ADDENDUM NO. 1

TO THE HVAC Improvements Project AT THE BARAGA COUNTY DHHS BUILDING

ADDENDUM NO. 1 is issued August 10, 2022 to clarify, modify, and/or change the original plans and specifications issued by U.P. Engineers & Architects, Inc. This ADDENDUM NO. 1 is hereby made part of the Contract Documents.

E101

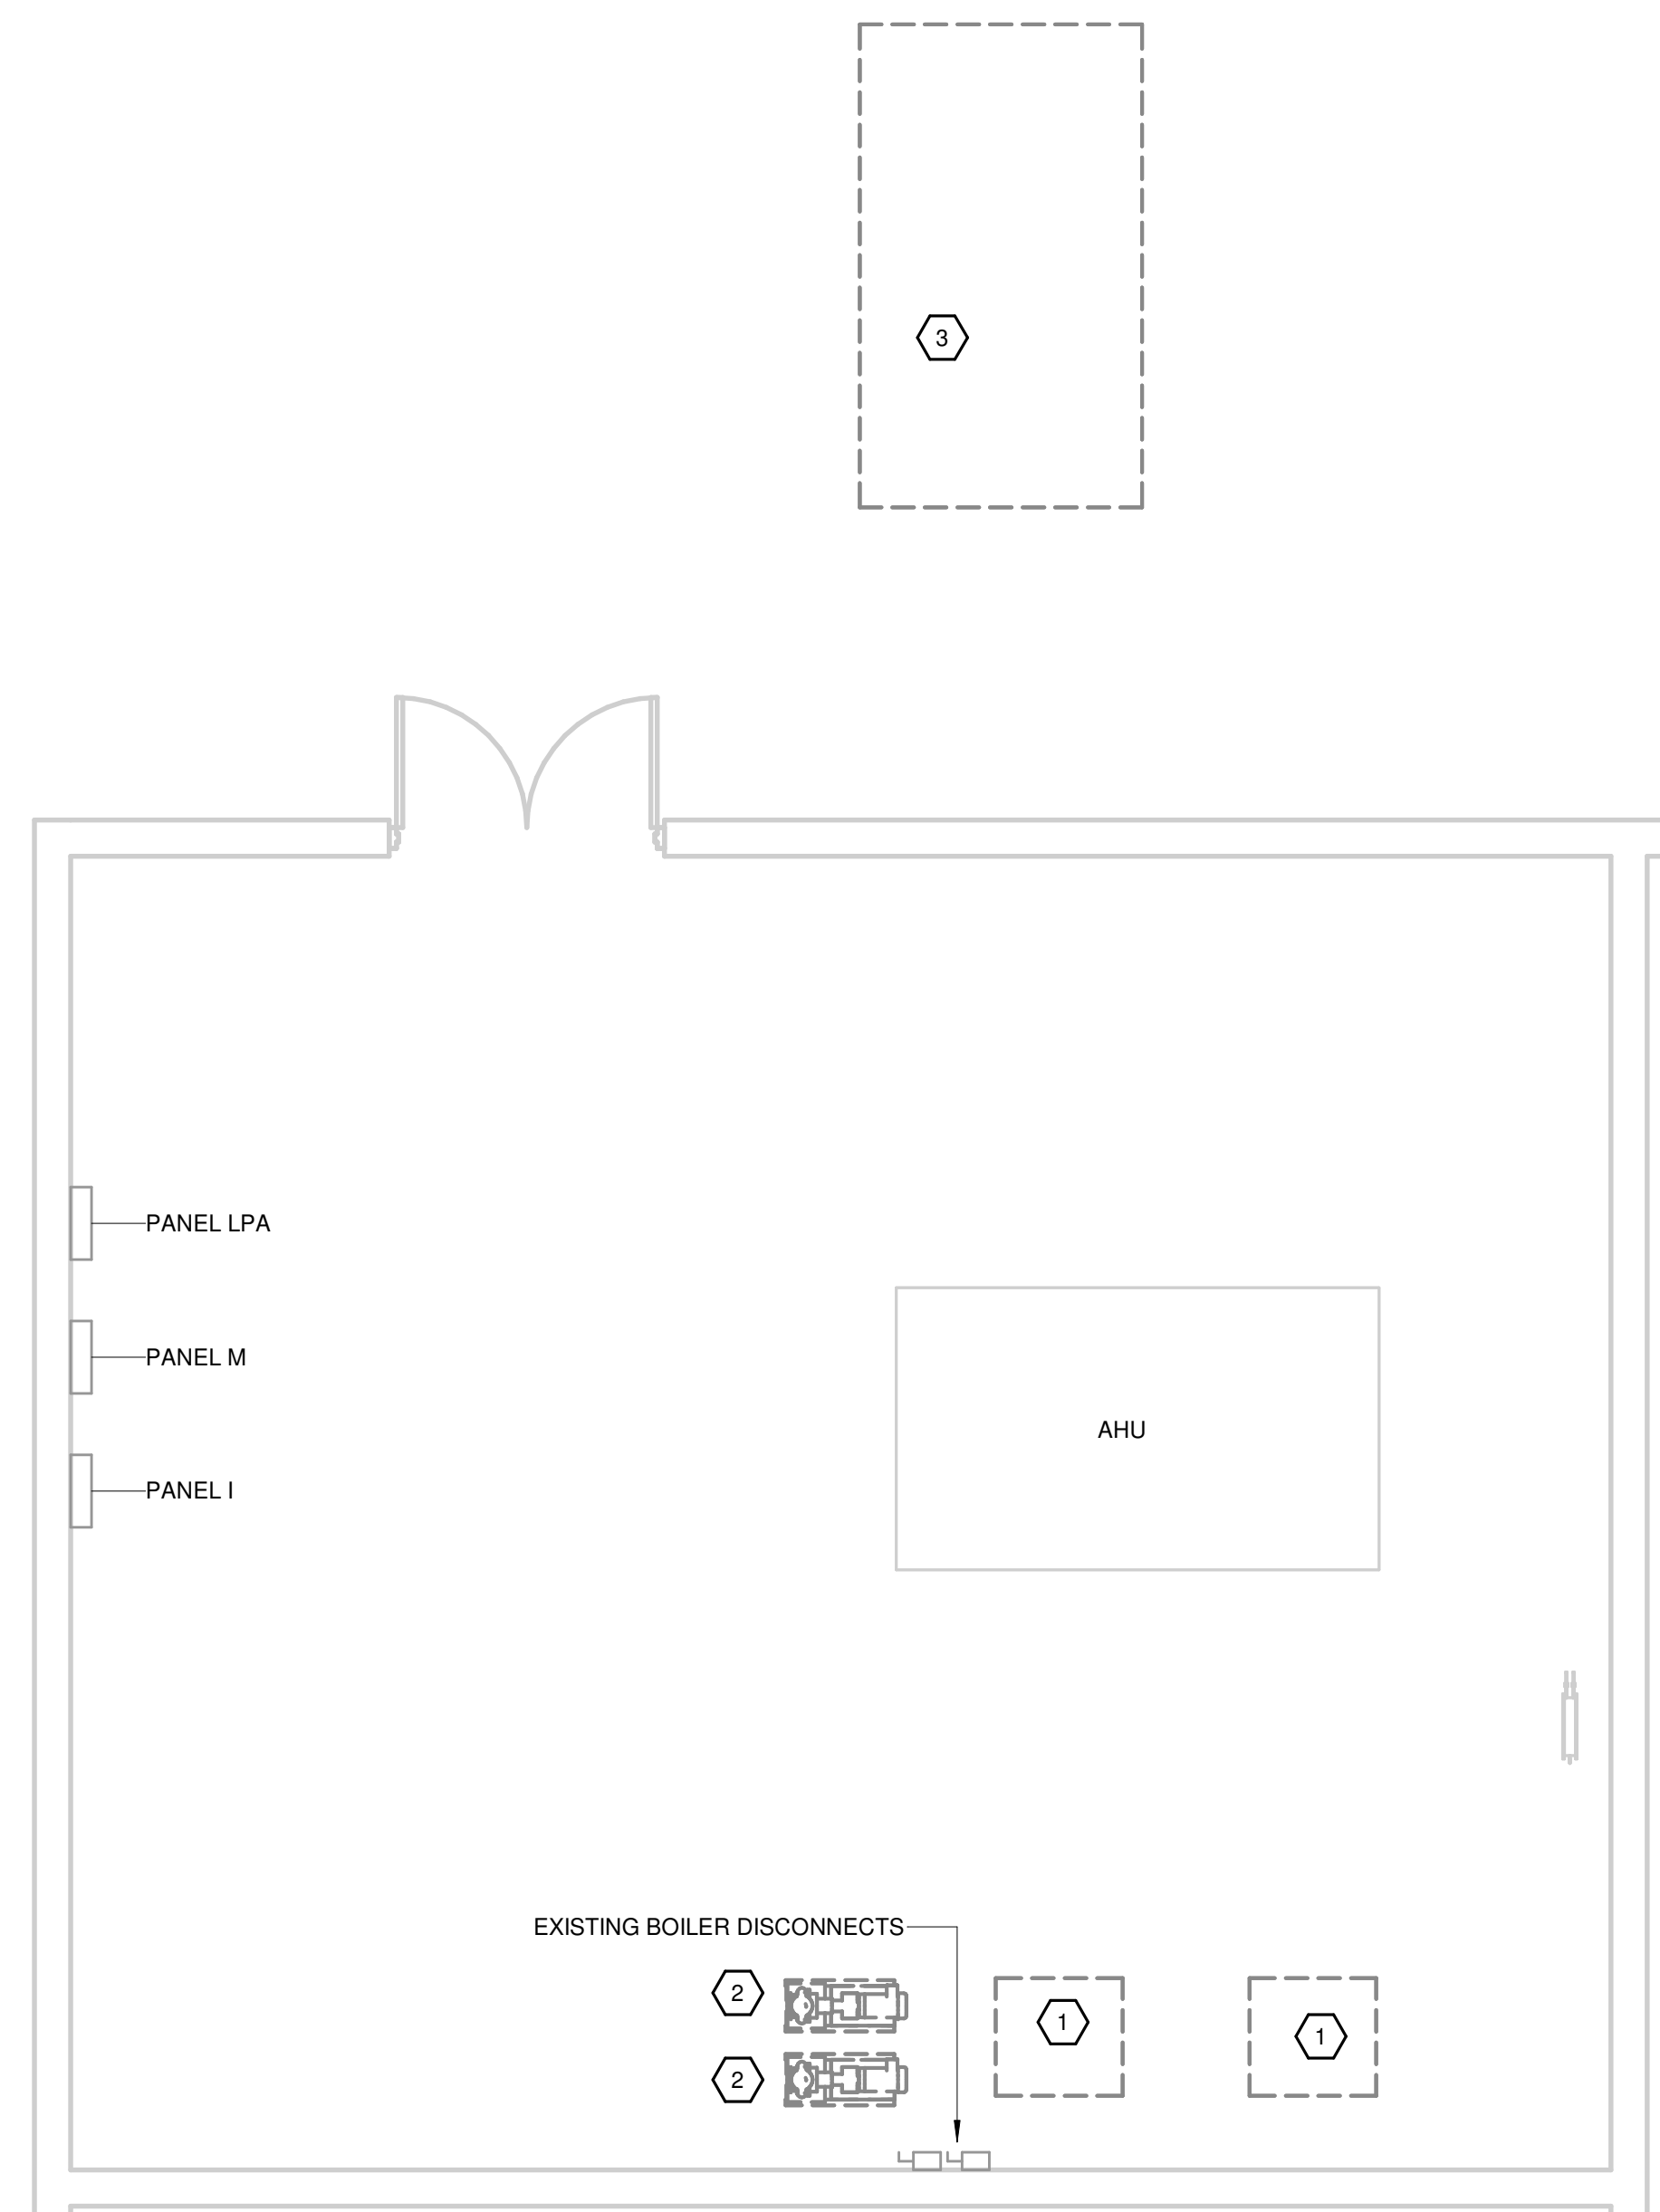
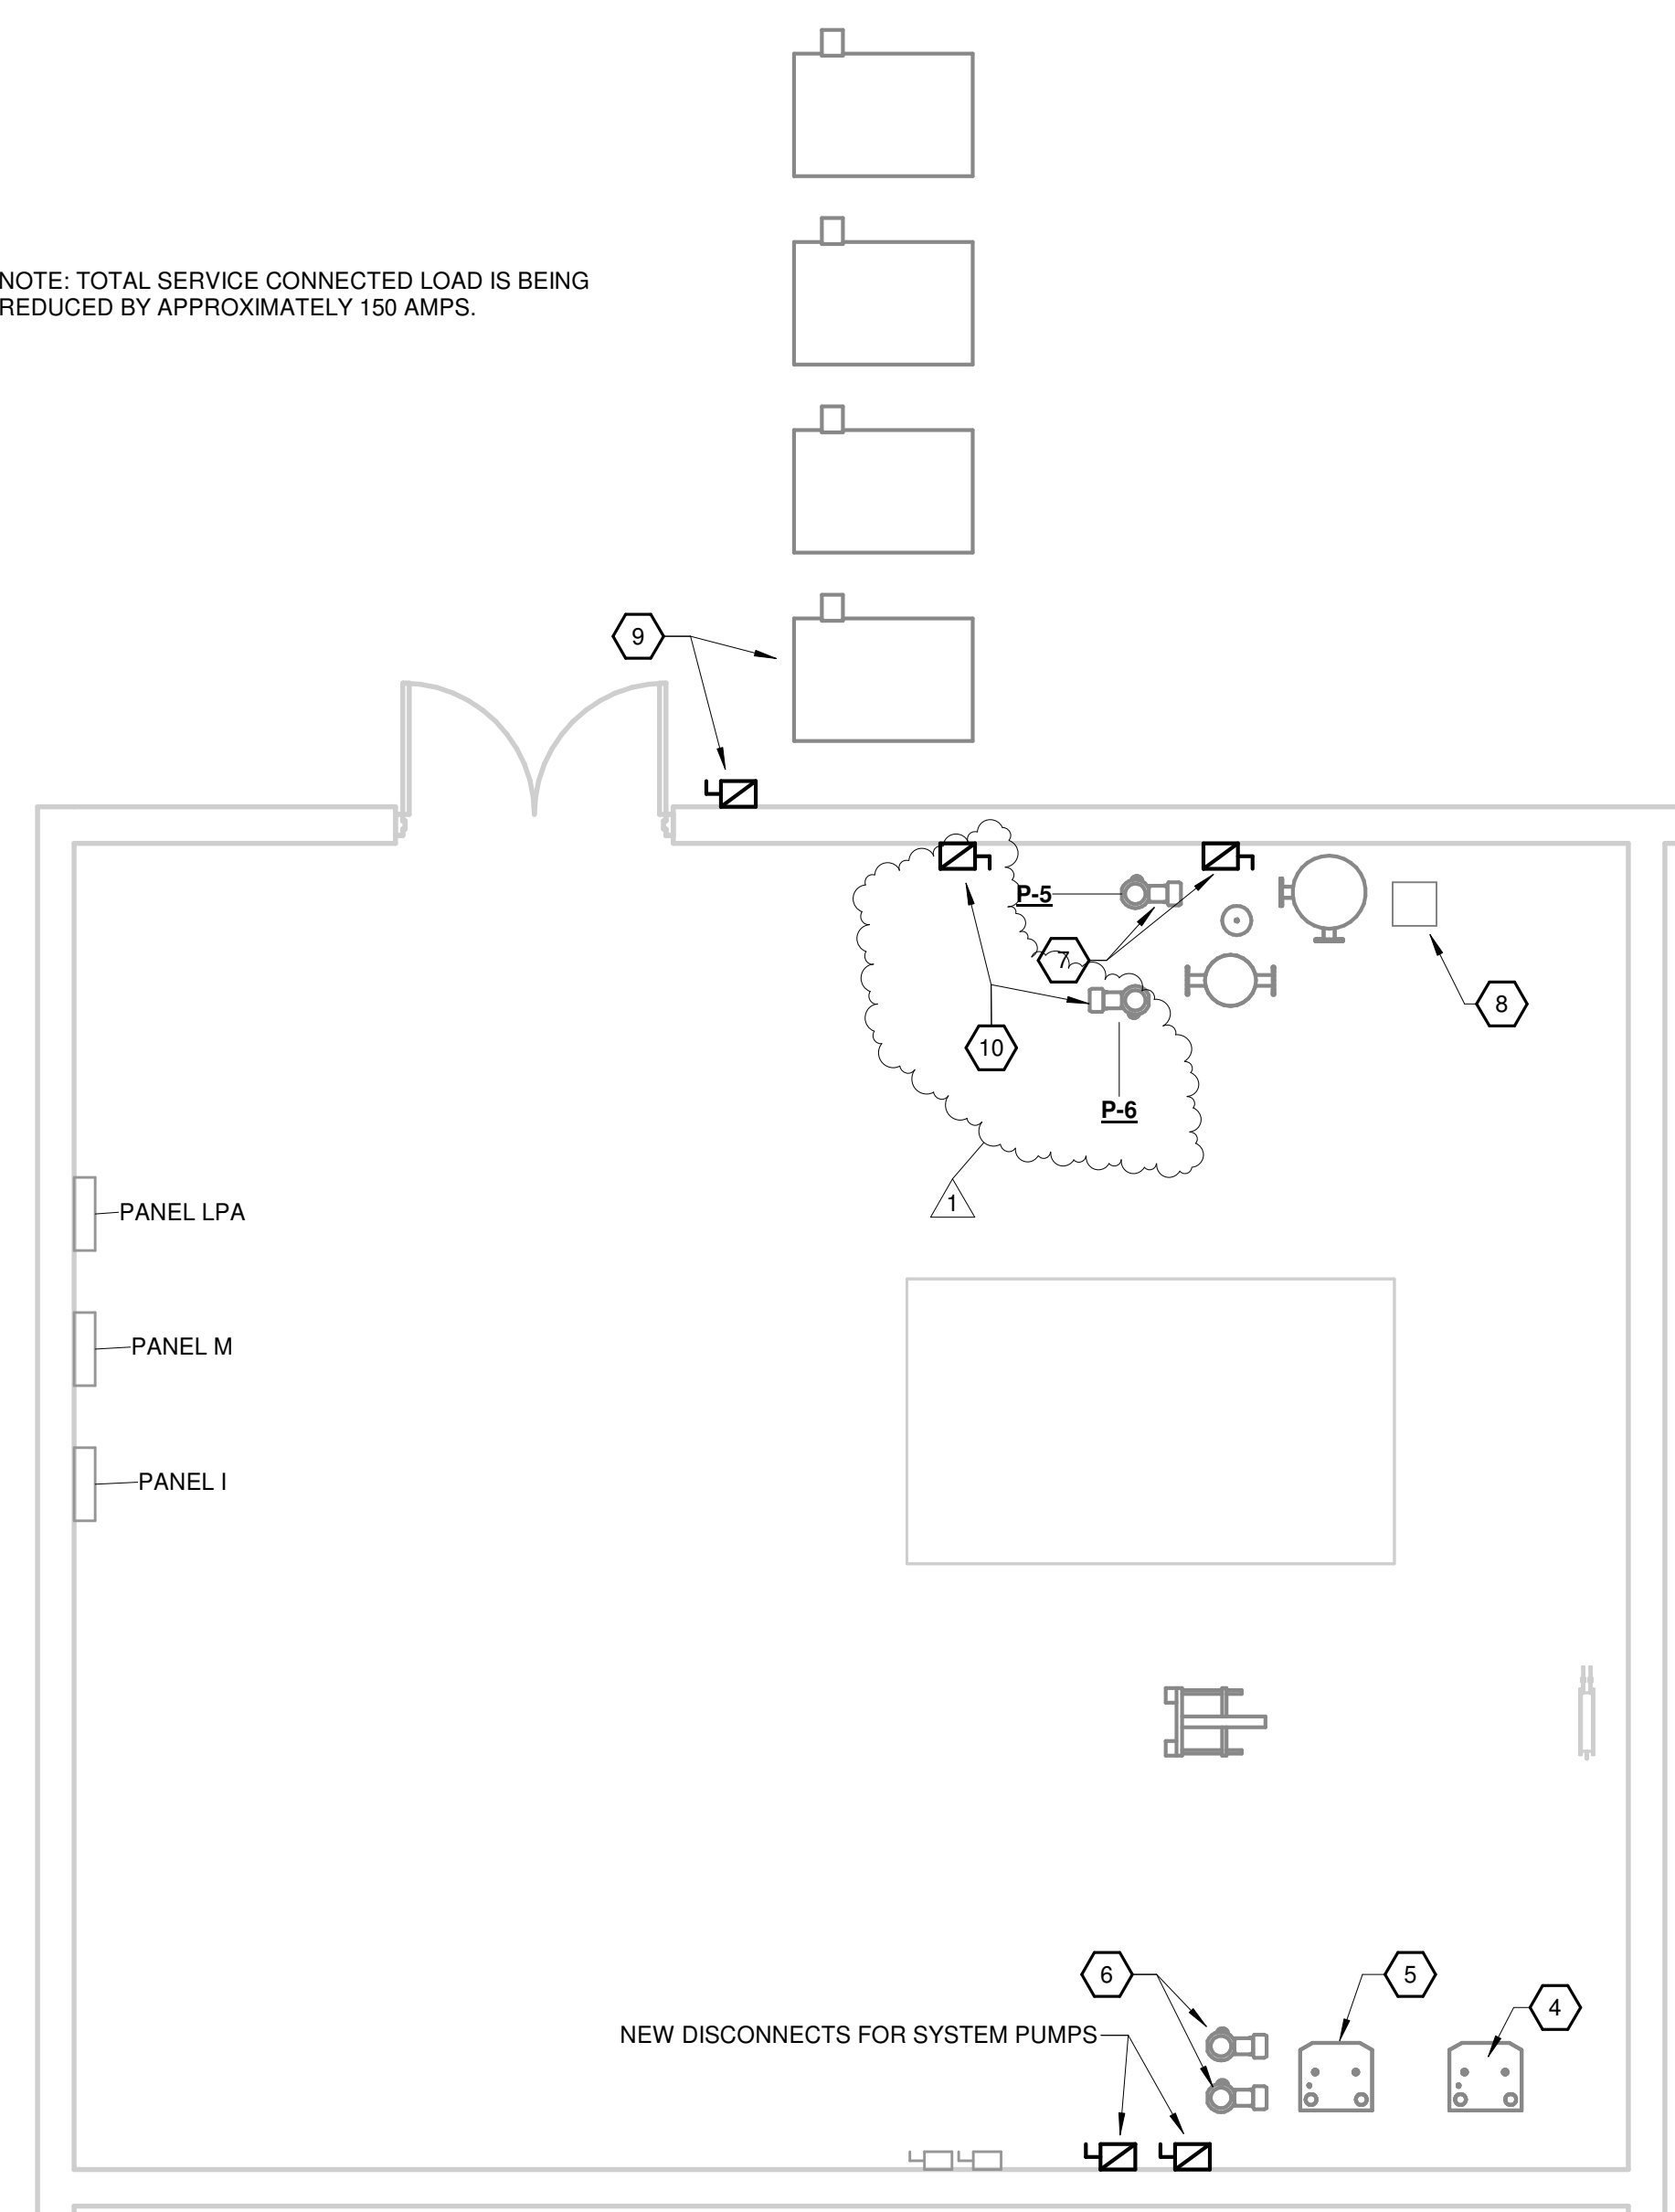
Add keynote 10 "Provide new 20A single pole breaker and 120V circuit for pump P-6. Provide new disconnect."

- 10 PROVIDE NEW 20A SINGLE POLE BREAKER AND 120V CIRCUIT FOR PUMP P.6. PROVIDE NEW DISCONNECT.
